Access Compliance Report

Public Rights-of-Way

Intersection ID: 53965	Main Street: MAGNOLIA_LILY_AV	Cross Street: SPRING_SPRUCE_LN	Location: NW
ADA ID: B30F87098223	Ramp Type: Perp	Initial Pass/Fail: Fail	Overall Compliance: No
Severity Score: 10			
Codes/Mitigation Info/Possible Solution		Field Measurements/Component Compliance

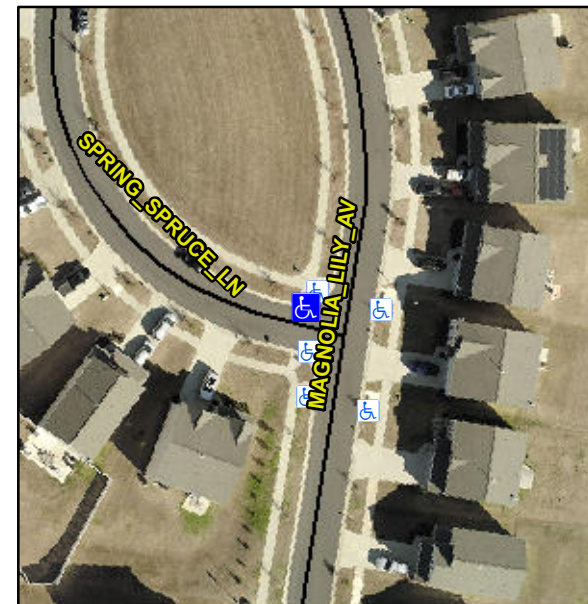
Remove & Replace Entire Ramp.

R304.5.1, R304.5.3

Compliance	Description	Data	Compliance	Description	Data
N/A	Ramp Length (in)	96.0	Yes	Ramp Slope (%)	5.0
No	Ramp Width (in)	47.5	No	Ramp XSlope (%)	2.4
N/A	Flare Type LT	N/A	N/A	Flare Type RT	N/A
N/A	Flare Slope LT (%)	N/A	N/A	Flare Slope RT (%)	N/A
N/A	Flare Traversable LT?	N/A	N/A	Flare Traversable RT?	N/A
N/A	Landing Length (in)	N/A	N/A	DWS Provided?	N/A
N/A	Landing Width (in)	N/A	N/A	DWS Contrast?	N/A
N/A	Landing Slope (%)	N/A	N/A	DWS Length (in)	N/A
N/A	Landing X Slope (%)	N/A	N/A	DWS Full Width?	N/A
N/A	Landing Curb? (Y/N)	N/A	N/A	DWS Offset (in)	N/A
N/A	Shared Landing?	N/A			
N/A	Gutter Ponding?	N/A	N/A	Gutter Slope (%)	N/A
N/A	Gutter Lip Ht (in)	0.5	N/A	Gutter X Slope (%)	N/A
N/A	Painted X Walk1?	No	N/A	Painted X Walk2?	N/A
	X Walk 1 Direction	To S		X Walk 2 Direction	N/A
N/A	X Walk 1 Width (in)	N/A	N/A	X Walk 2 Width (in)	N/A
	X Walk 1 Slope (%)	2.3		X Walk 2 Slope (%)	N/A
	X Walk 1 X Slope (%)	4.0		X Walk 2 X Slope (%)	N/A
